Public Works Department – Engineering Division

ADDENDUM NO. 4

PROJECT 5067 WTP FILTER IMPROVEMENTS AND HYPOCHLORITE CONVERSION

BY: KME	DESCRIPTION: APPENDUM NO. 4	DATE: 03/24	REV: 01	SCALE: 1" = 10'
DRAWN: SMB	CHECKED: TRB	REVIEWED: AWS	DATE: 1/19/2024	
SHEET NO. 23 OF 232				
DWG. NO. C105

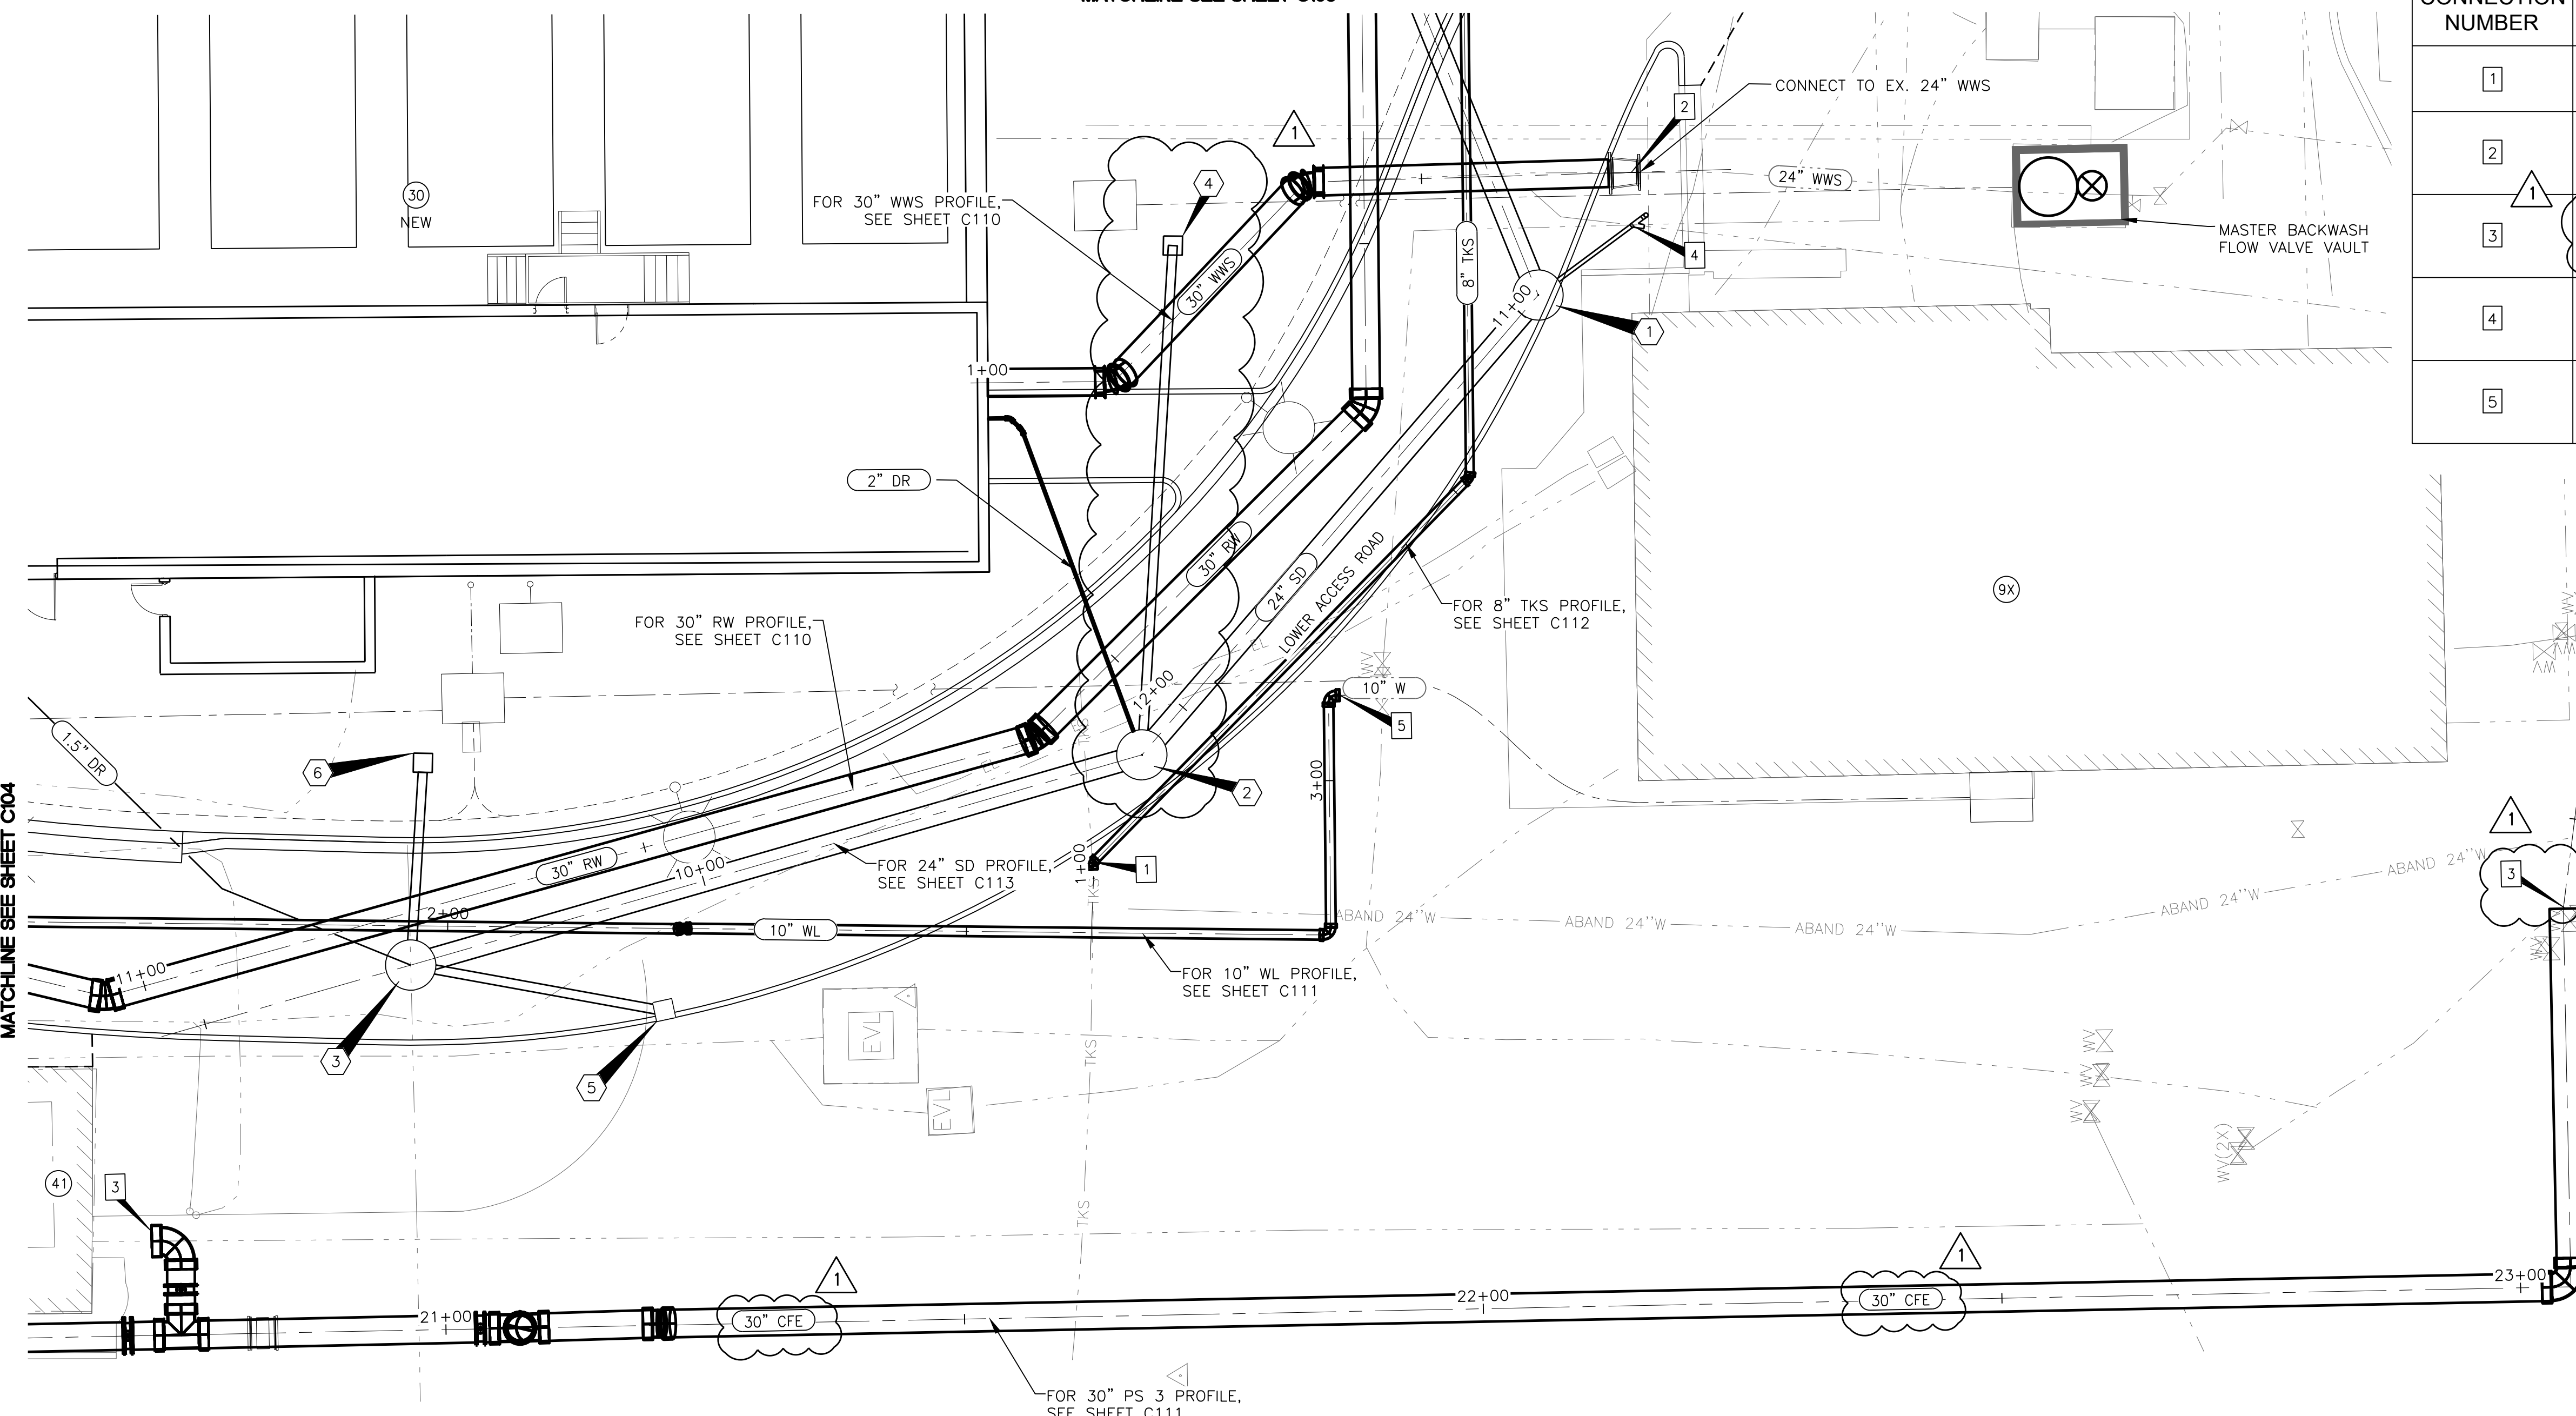
12. Replace Drawing C105 with the attached updated drawing C105.

9. On Sheet C105, a 10" WL is proposed, but the line is shown as 30". Please advise.

Response: Sheet C105 has been revised. Please see this addendum, Item A.12.

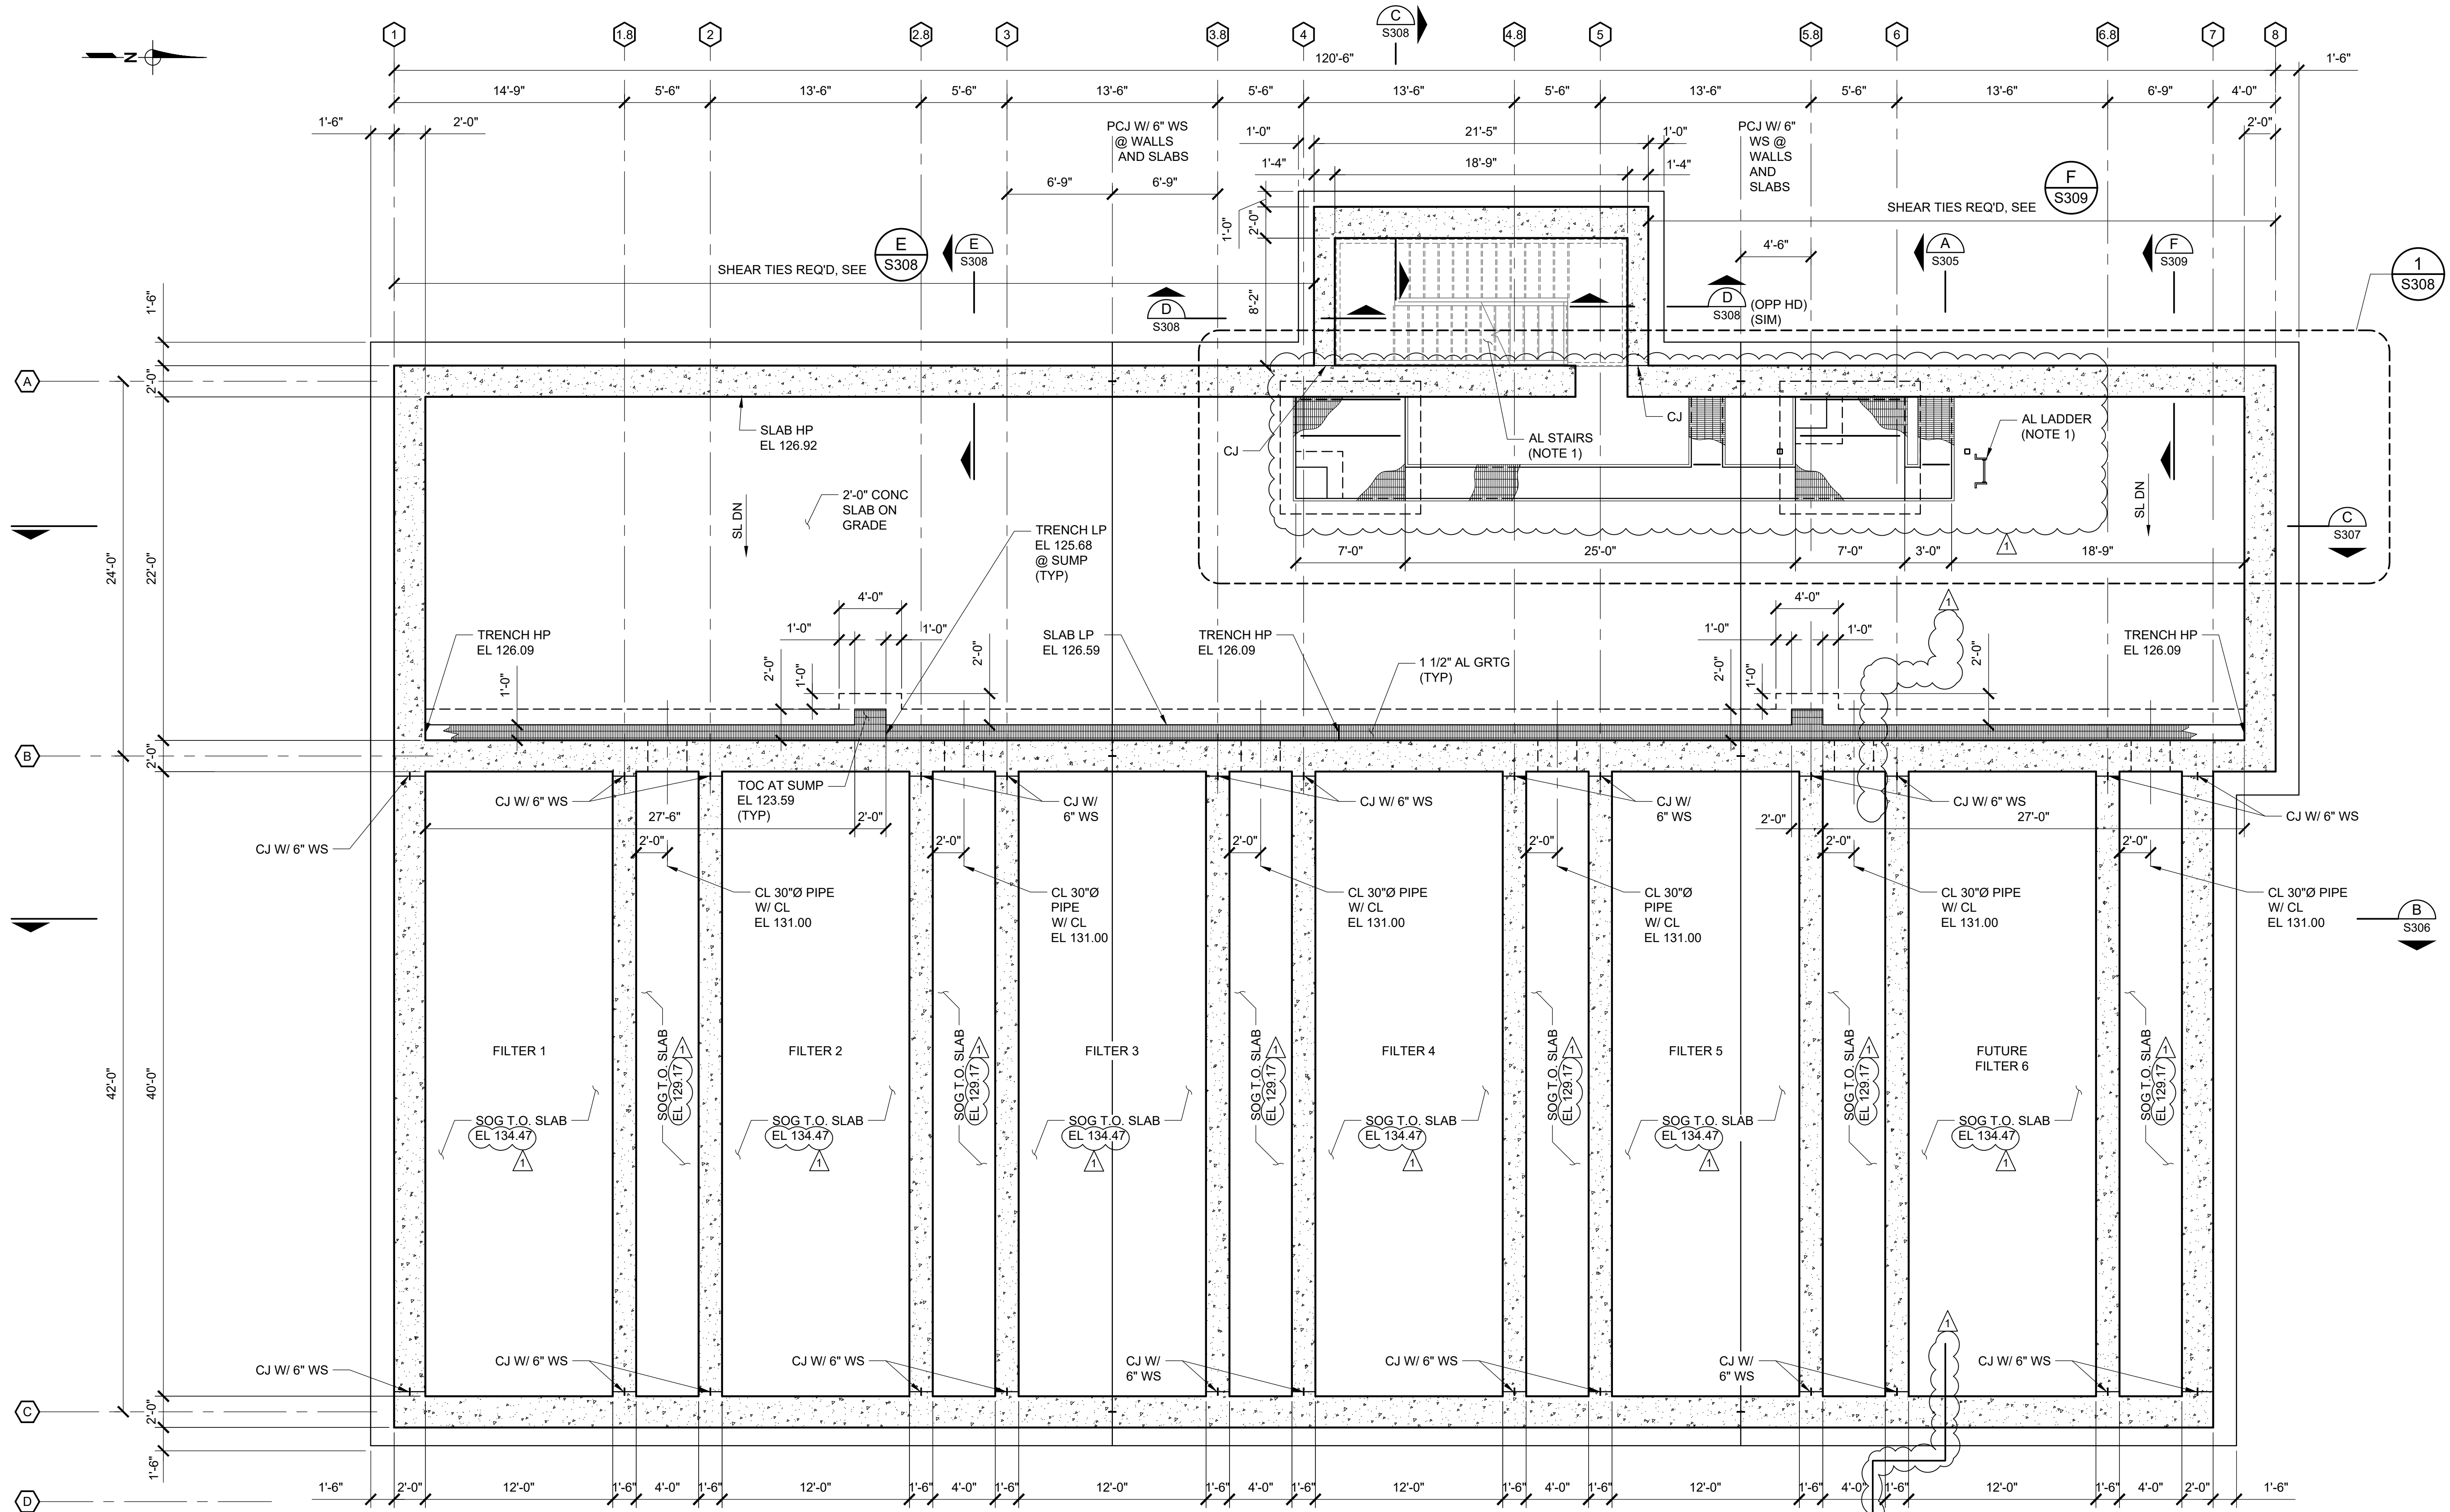
21. Remove all references to wet testing in Specification 41 22 13.13.
22. Replace Drawing C102 with the attached updated drawing C102.
23. Replace Drawing S301 with the attached updated drawing S301.

55. Rev 1 Drawing A102 provided in Addendum 3 added Keynote 14 which says, "Metal Ladder Per Structural Drawings." The ladder shown in the Architectural plan view on the north side of the EL. 142 Platform is not shown on the Structural Drawings, or the Rev 1 Section on A108 provided in Addendum 3. The addition of this ladder is also not mentioned in A.1, Additions/Deletions/Revisions of Addendum 3. Please confirm the addition of the ladder, and if confirmed, provide a corresponding section view as well as an applicable detail for this Ladder. Detail 05561 provided in Addendum 3 requires connections to a vertical concrete surface @ 4'-0" OC max. which would not be possible at the Keynote 14 callout location.

65. Reference sheet S301 and section A/S305. Drawing sheet S301 shows section A/S305 being cut through the filter plenum/gullet. The section view shown on S305 appears to be a cut through the filter area. Please revise cut location or section view or clarify.

Response: Metal ladder has been added to the structural drawings. See updated Structural drawings S301 and S302 in Item A.23 and A.24 above. The ladder is a deferred submittal that requires the Contractor to submit engineering design calculations and details that are prepared, stamped and signed by a California licensed civil or structural engineer.

Response: On Sheet S301, Section A cut will be revised to cut through the filter area. See this addendum, Items A.23 and A.24.
